# AXOD/AXODE (AX4S) UPDATE HANDBOOK

# INTRODUCTION

This updated version of the AXOD "Update Handbook" will also cover the changes that occurred in the 1991 model year, when electronic controls were adapted to the AXOD transaxle, making it an AXODE, and now called an AX4S transaxle. We have included the changes on the AX4S transaxle up through and including model year 2002.

Figure 1

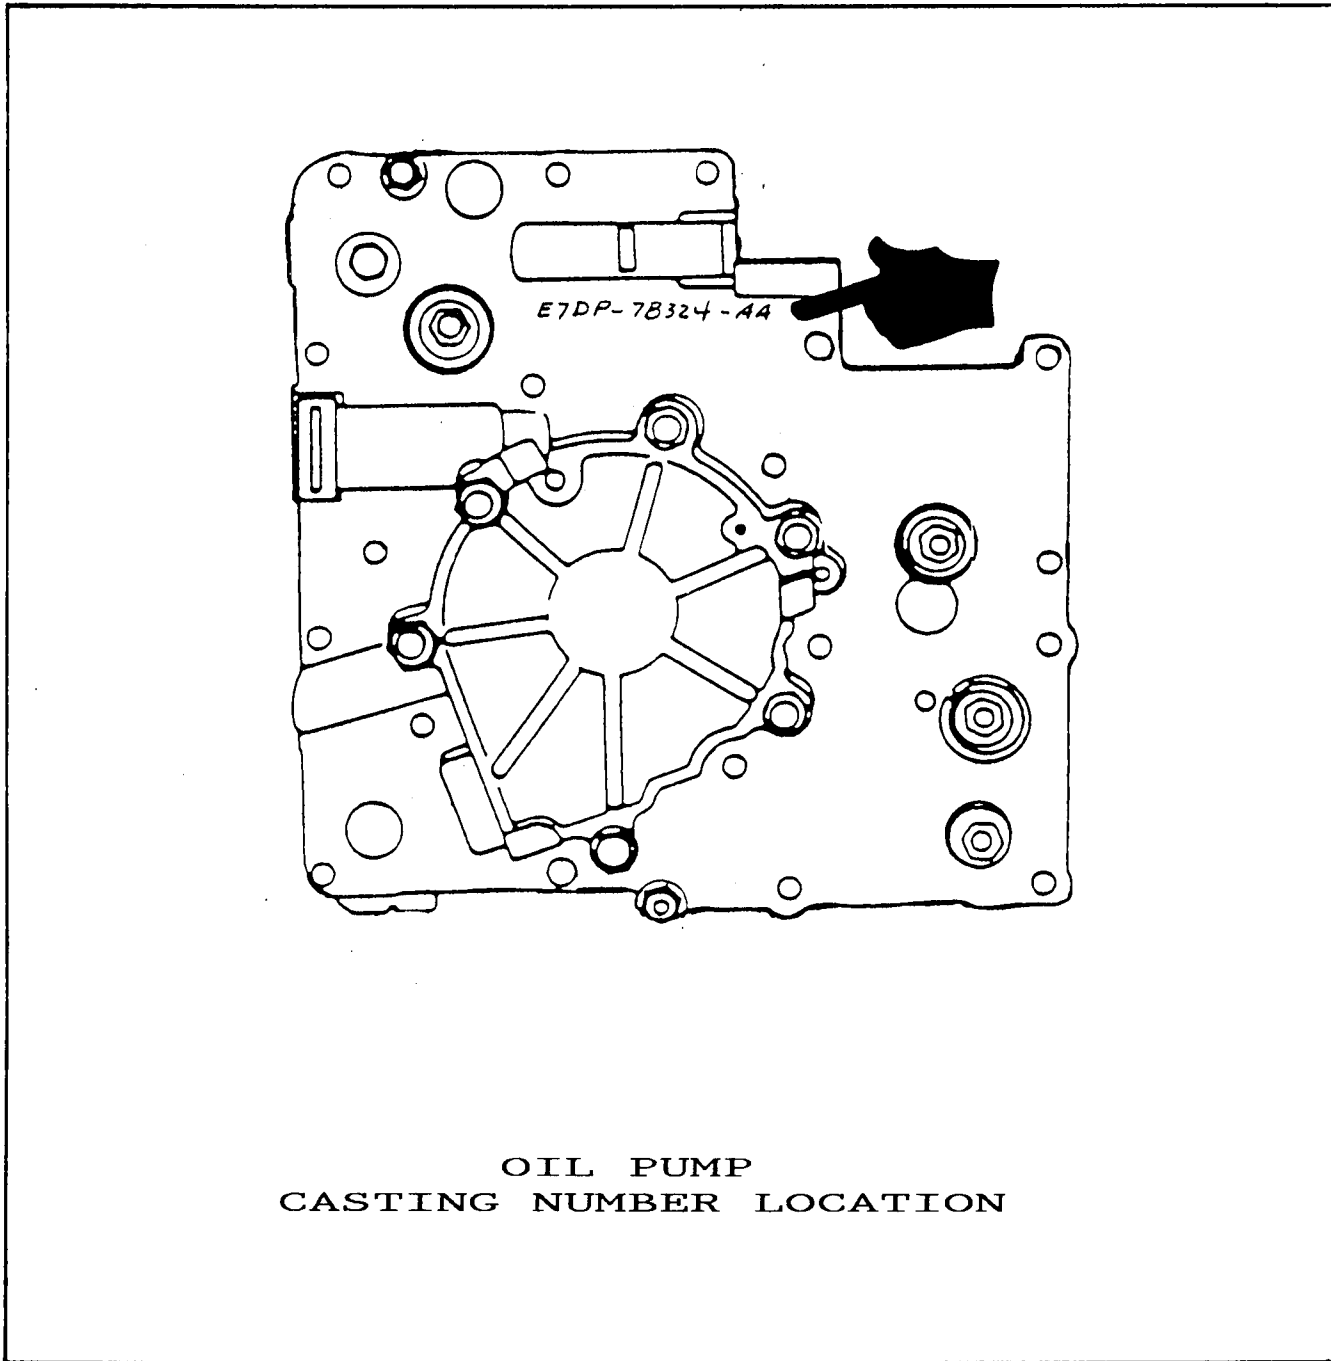
- (1) OIL PUMP CASTING - Must be identified by the casting number located on the pump as shown in Figure 1, and can be identified as follows:
  - E6SP-7B324-AA = 1986 Hydraulics.
  - E7DP-7B324-AA = 1987 Hydraulics.
  - E8DP-7B324-AA = 1988 Hydraulics.
  - E9OP-7B324-AA = 89/90 Hydraulics (10 Checkball Pump).

Figure 2

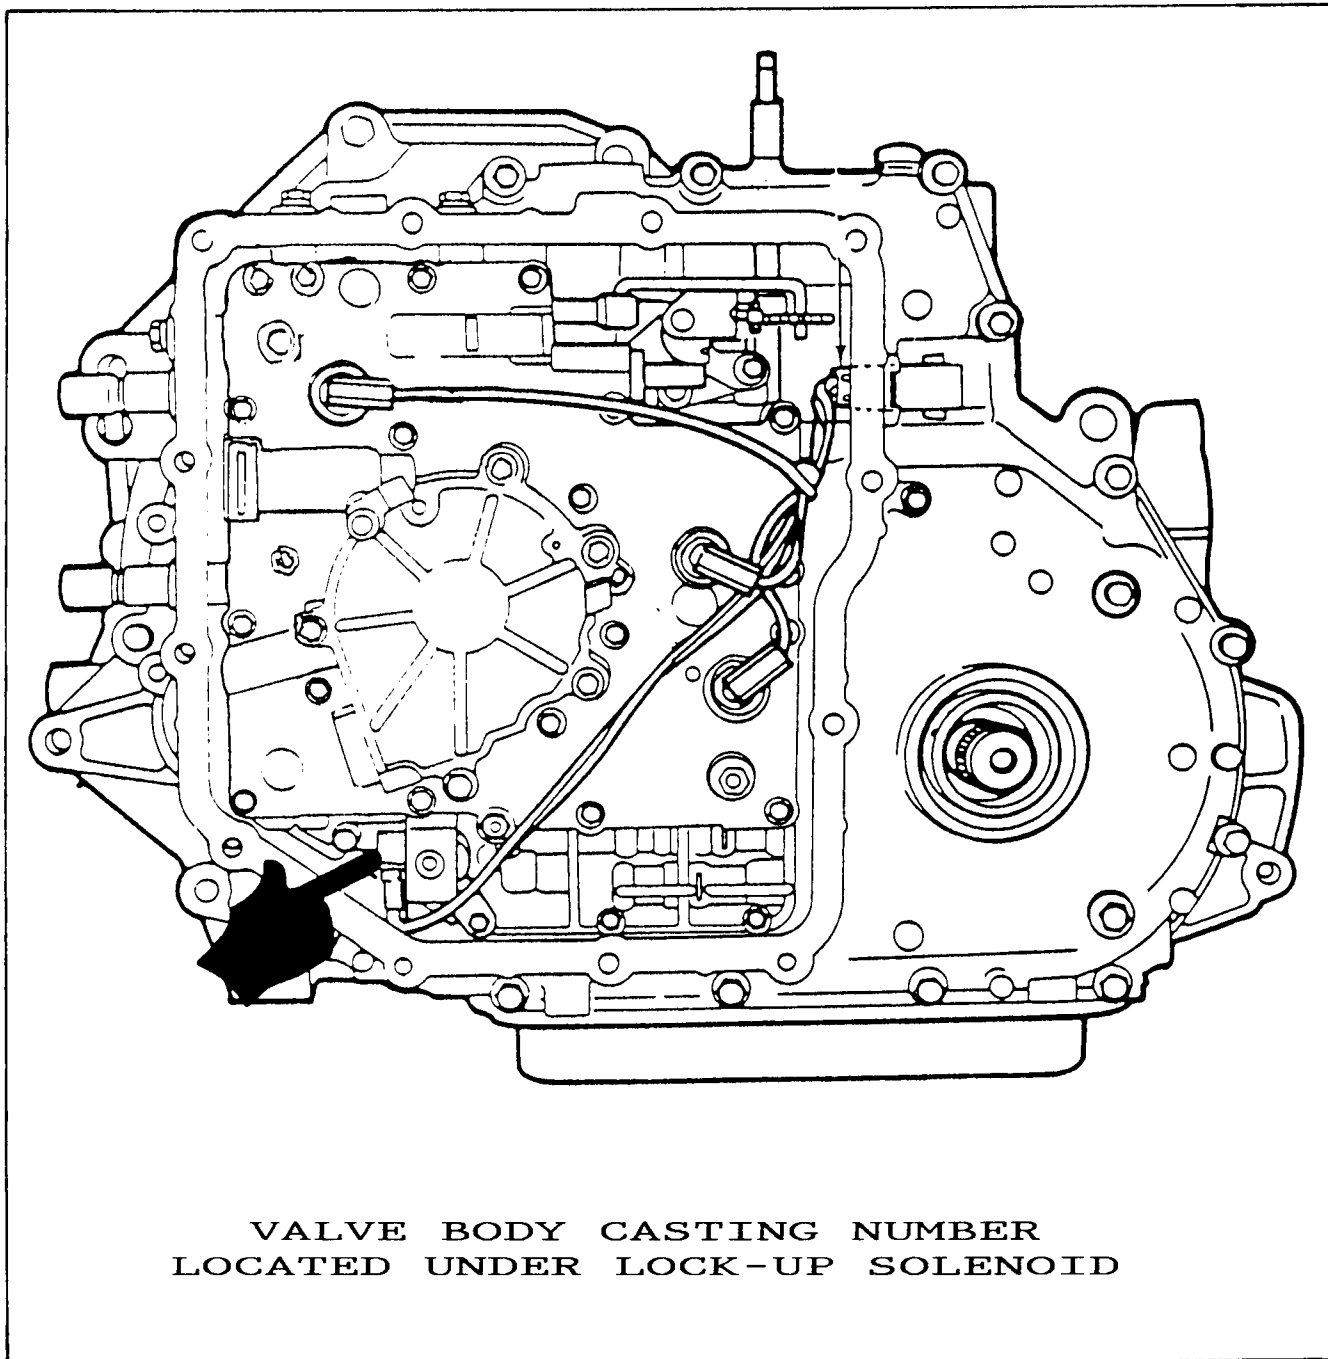
NOTE: Some 1987 models had 1986 pumps, but had 1987 spacer plate, and requires 1987 pump spacer plate gaskets.
- (4) VALVE BODY CASTING - Must be identified by the casting number located beneath the lock-up solenoid as shown in Figure 2, and can be identified as follows:
  - E6SP-7A092-AD = 1986 Hydraulics Only.
  - E7DP-7A092-BA = 1987 Hydraulics Only.
  - E8DP-AA = 88/90 Hydraulics Only.

Figure 3

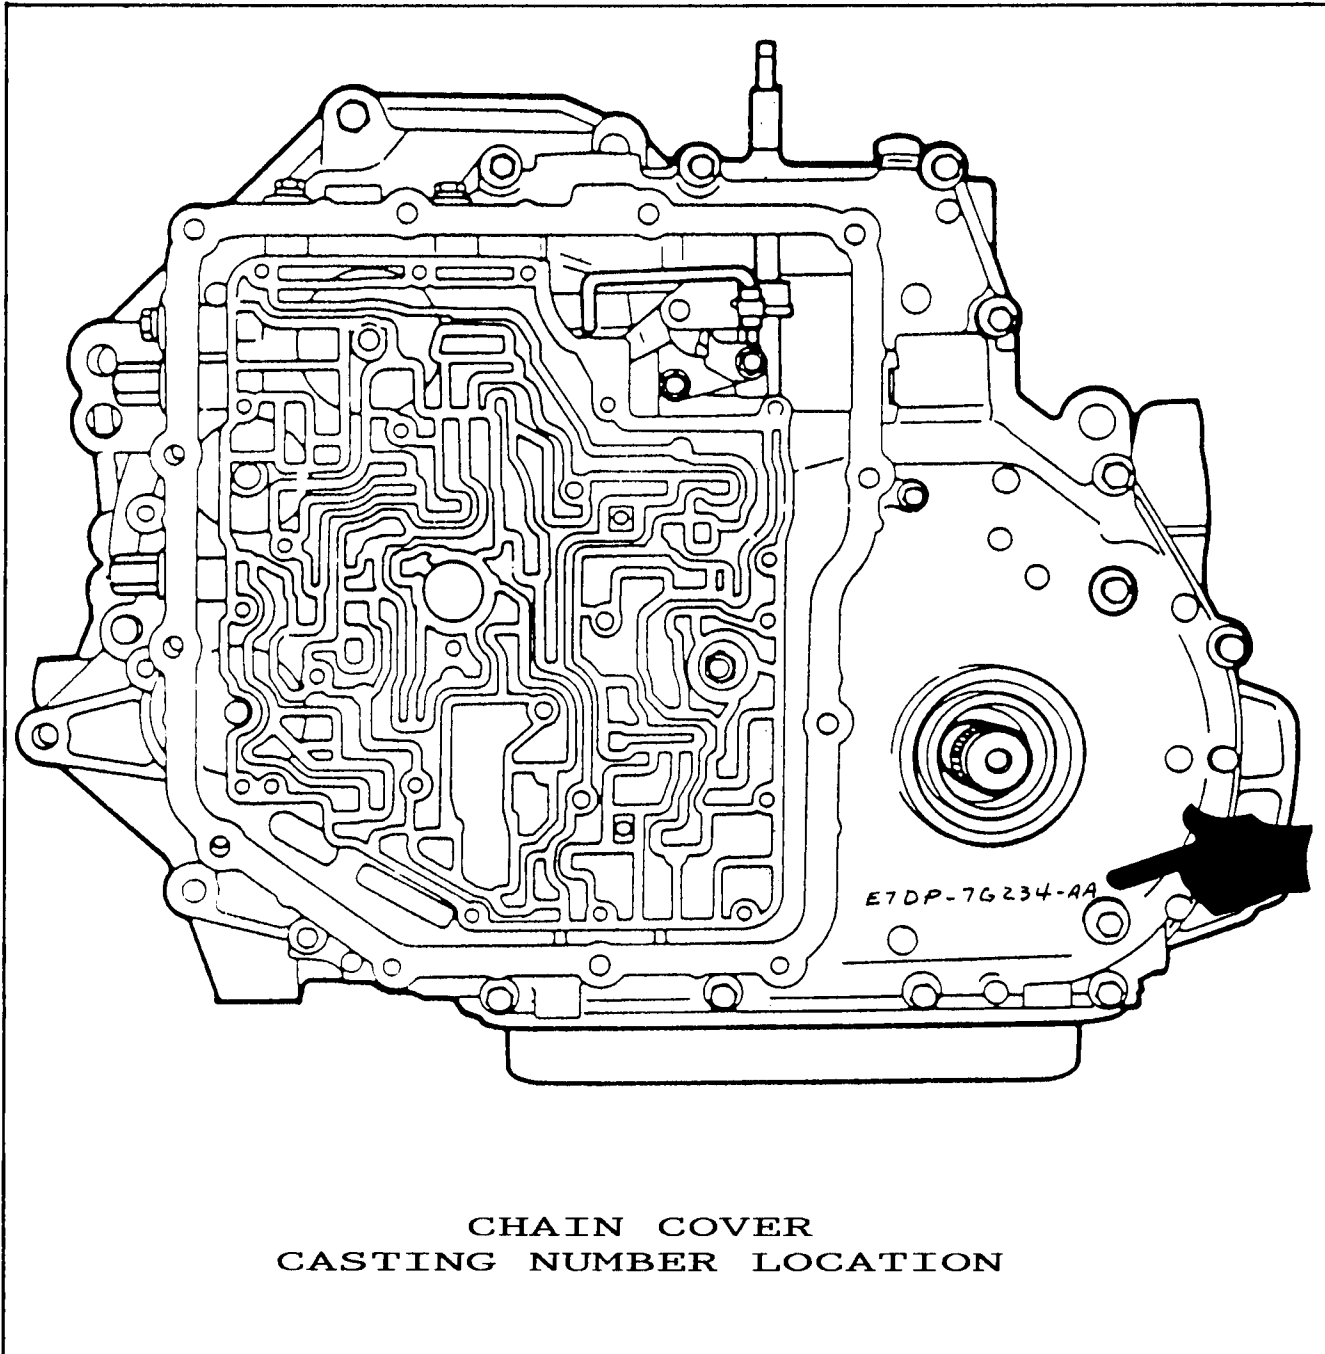
- (7) CHAIN COVER - Must be identified by the casting number located below the axle seal as shown in Figure 3, and can be identified as follows:
  - E6SP-7G234-AA = 1986 Hydraulics Only.
  - E7DP-7G234-AA = 1987 Hydraulics Only.
  - E8DP-7G234-AA = 88/90 Hydraulics Only.
- (8) OIL PUMP CHECKBALL LOCATIONS - The 1986 through 1989 oil pumps have 9 checkballs, and locations are shown in Figure 16. Some 1989 models and all 1990 model oil pumps have 10 checkballs, and locations are shown in Figure 17.

Figure 18

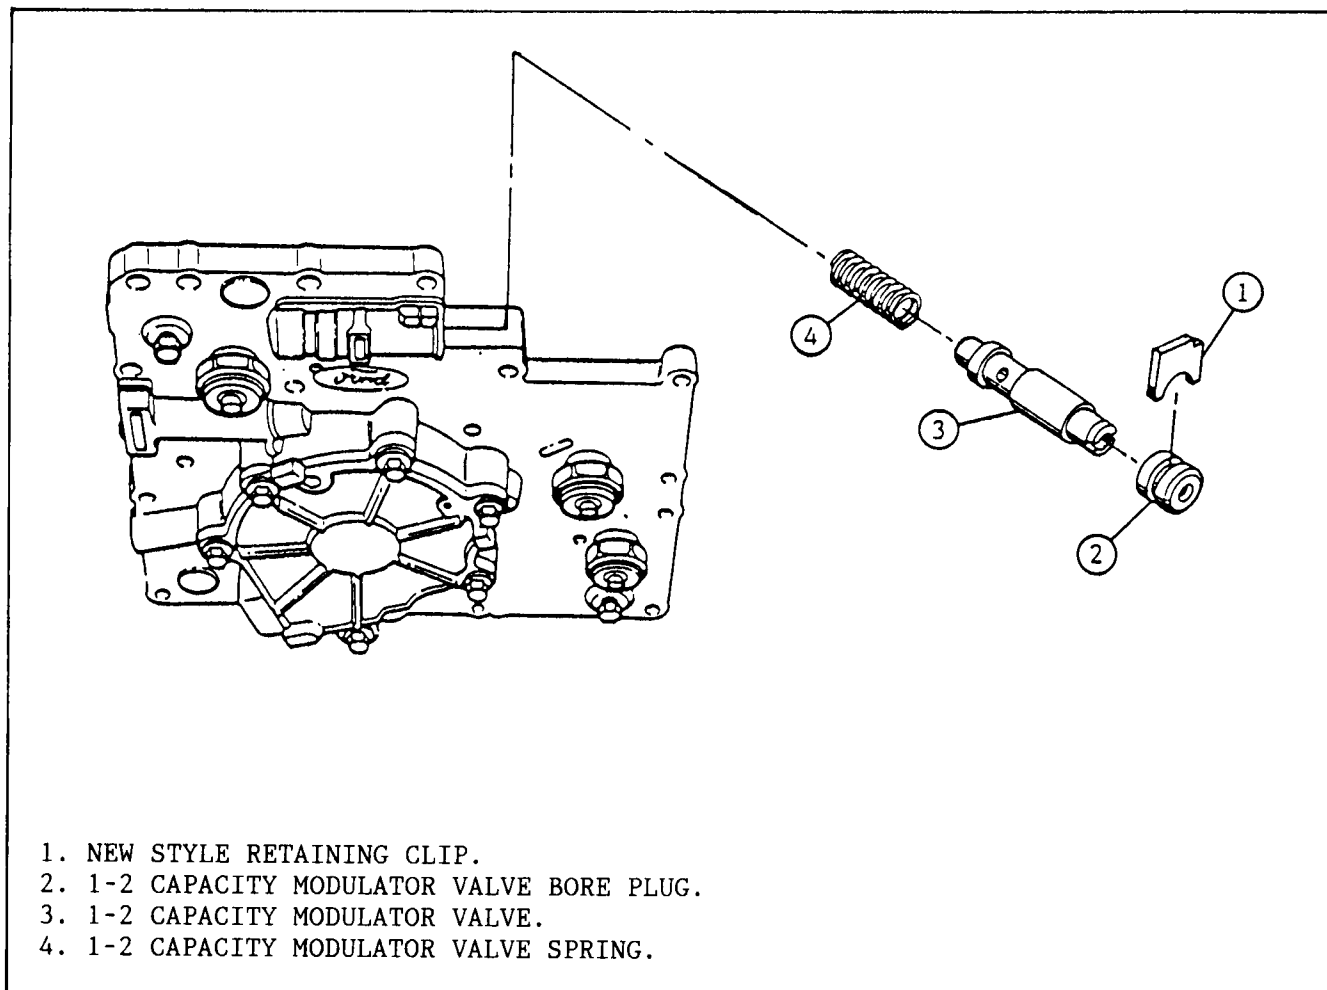
CORRECTION: FOR SOFT 1-2 SHIFT:  
Replace the 1-2 capacity modulator valve spring with the Red spring manufactured by Shift Technology Products (Part #K006). The kit also comes with a new style bore plug retaining clip. Assemble into the oil pump as shown in Figure 18. This modification should be made on all AXOD'S during rebuild.

Figure 19

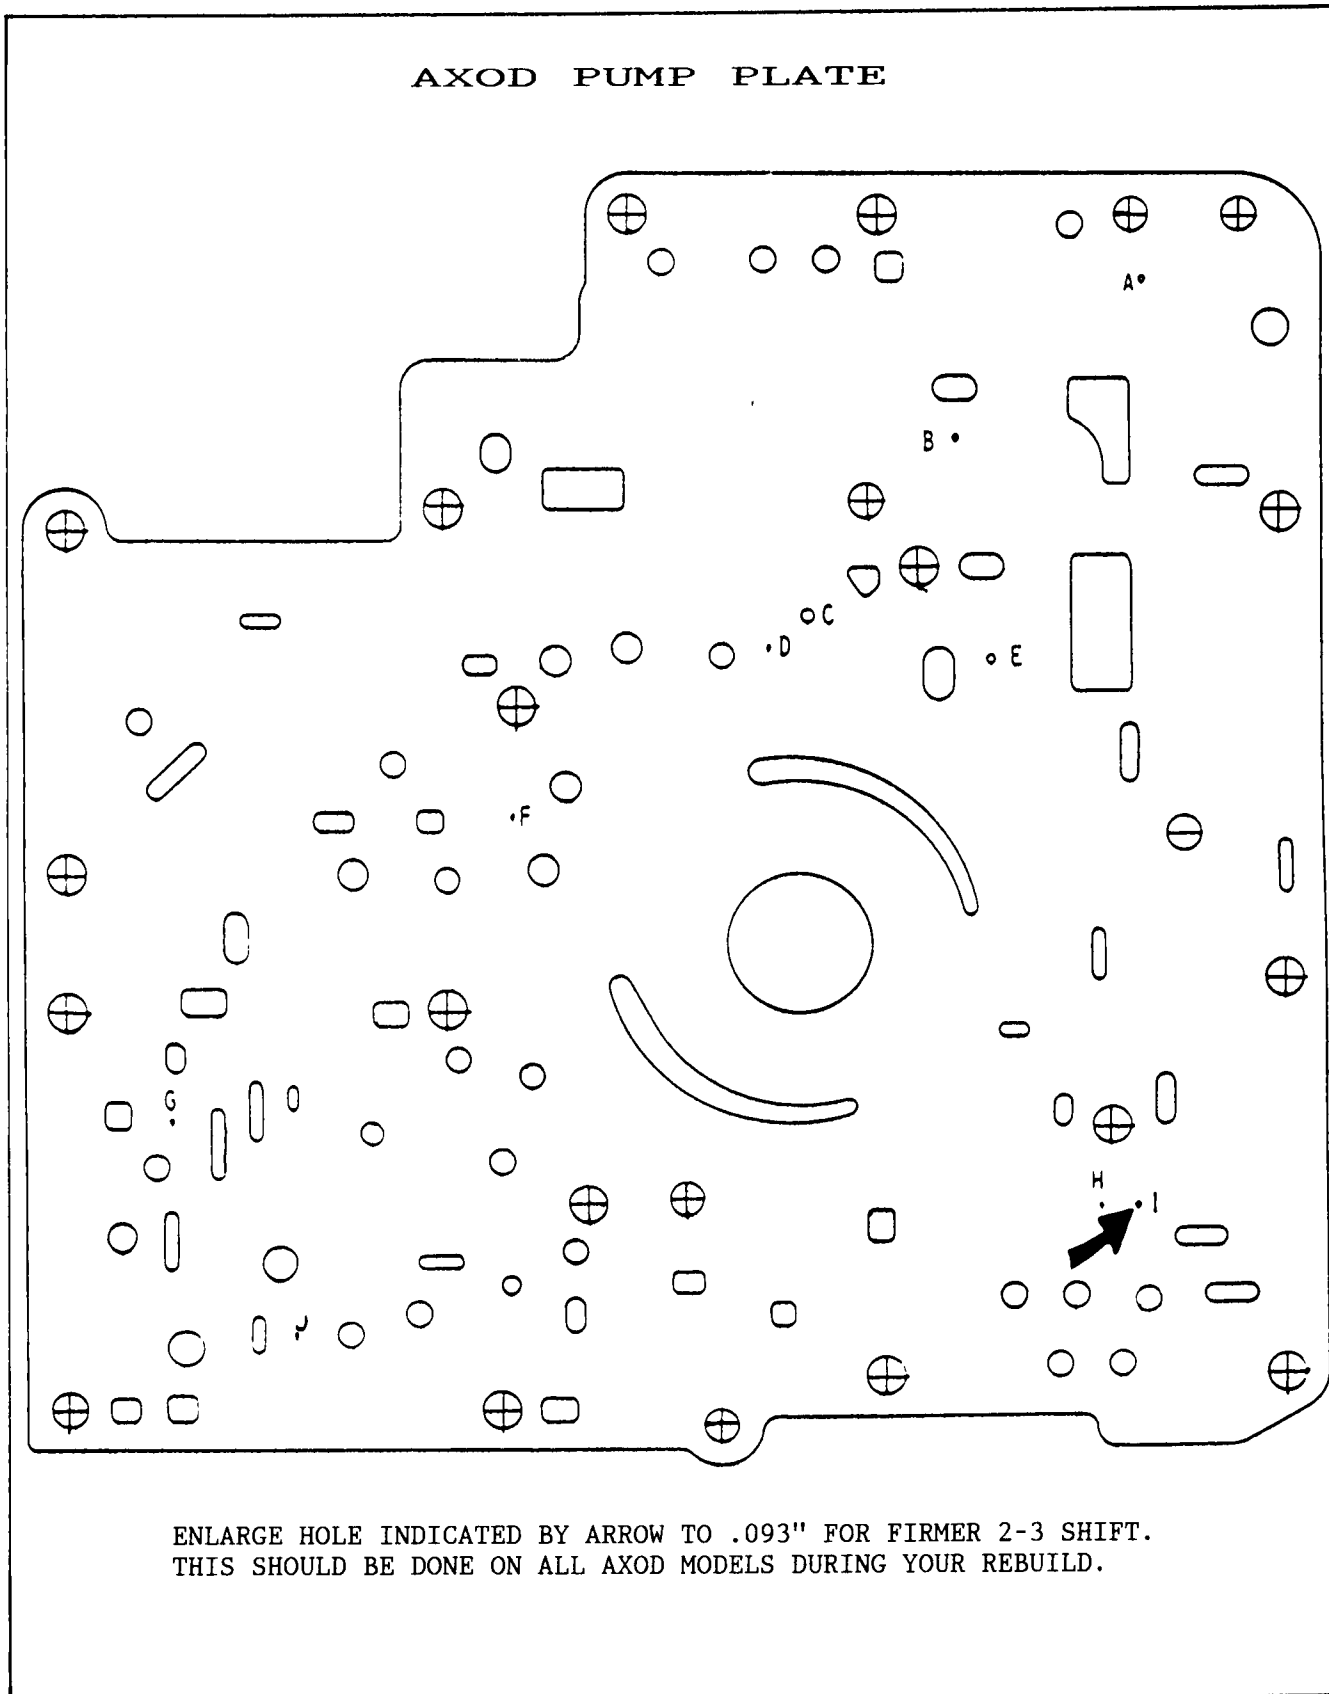
FOR SOFT 2-3 SHIFT:  
Drill the direct clutch feed passage in the oil pump spacer plate, hole marked "I", out to .093" as shown in Figure 19.
